Memo

To: John Tunstall, PE
From: Jeff Walton, Associate Planner; jeff.walton@wilmingtonnc.gov
CC: File;
Date: 1/20/2016
Re: Flats at Main

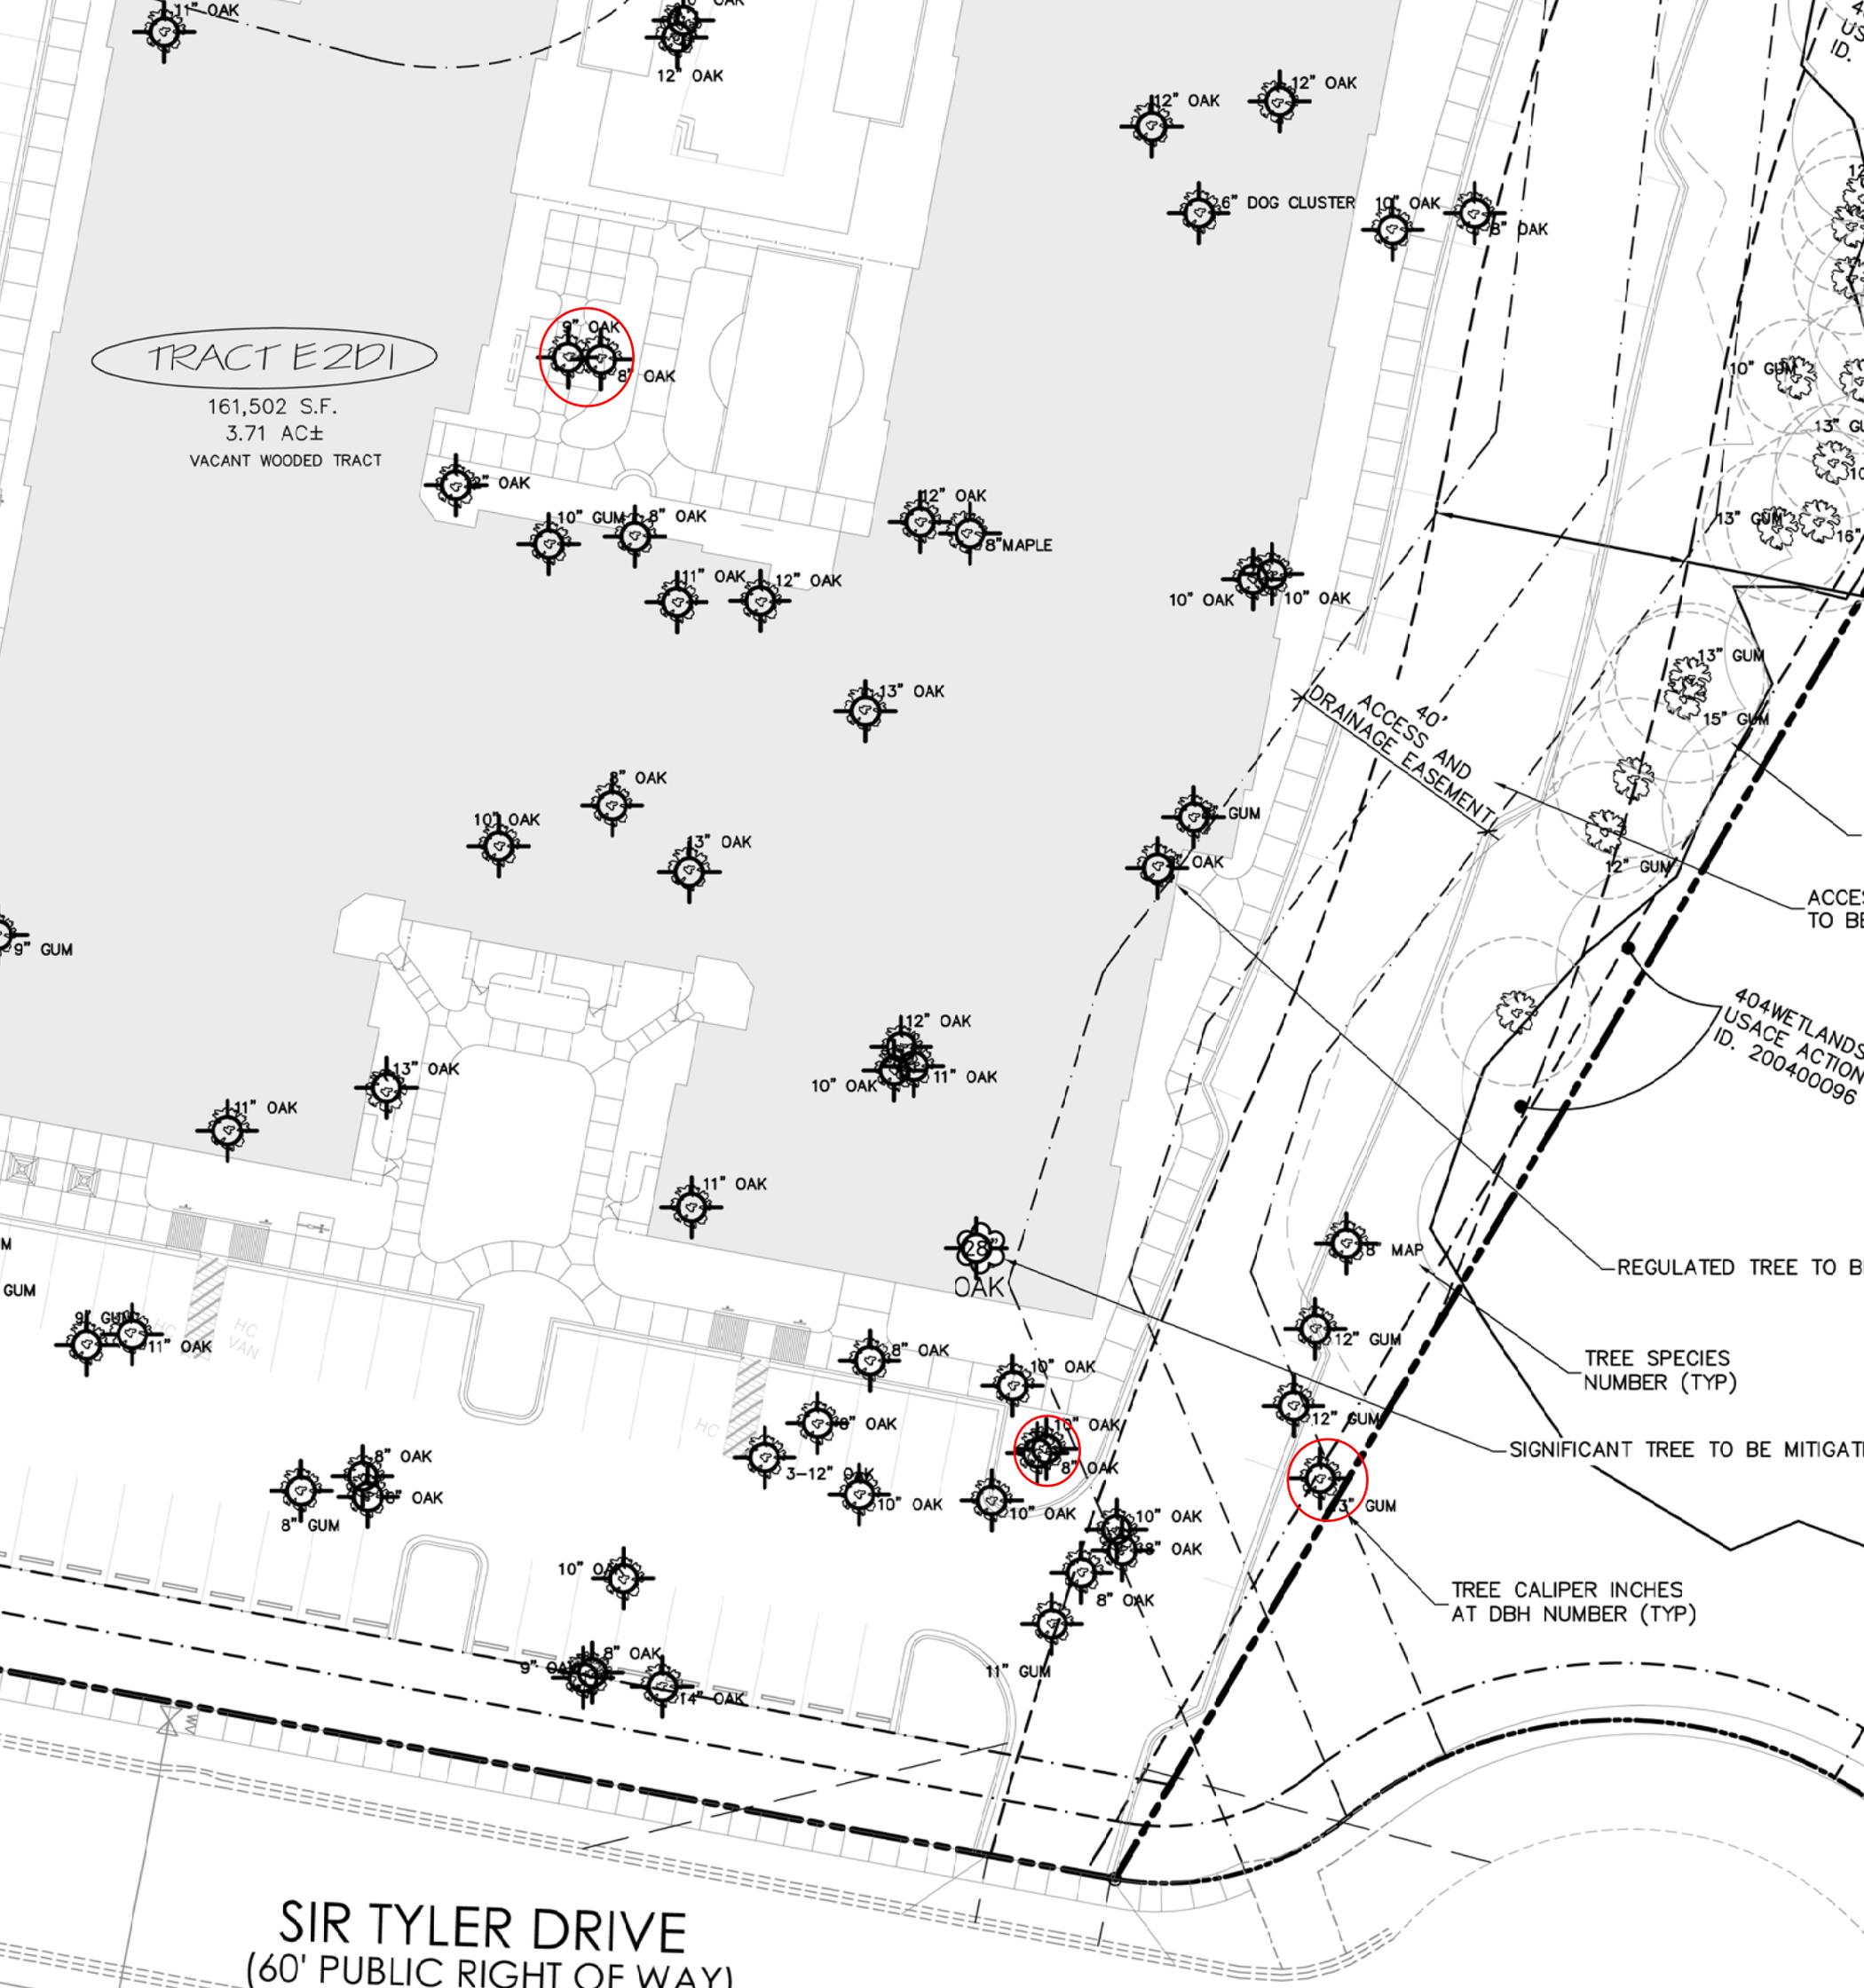
- Sec. 18-60 (c) (9): Show location and dimension of any easements, public rights-of-way, existing and proposed.
 - Is the access road going to be a public or private street? The street dedication will require SRB review. Please submit the Subdivision application and sets of plans for SRB review.
 - Is the street cross section on the plans?
 - I assume it's going to be a private street, show compliance with building setbacks.
 - I would expect a waiver of sidewalk on one side of the proposed street as well as the 500-foot variance will be heard at SRB? Please submit a variance letter addressing needed waivers.
- Sec. 18-60 (c) (16): Show site inventory map and tree survey.
 - I have made some redlines of trees that could be preserved. See attached.
- A tree preservation/removal permit is required

- Label which trees are part of the mitigation of 35 trees.
- Since parking faces Sir Tyler, a low buffer of continuous shrubs must be shown and be 3-feet in height when planted.
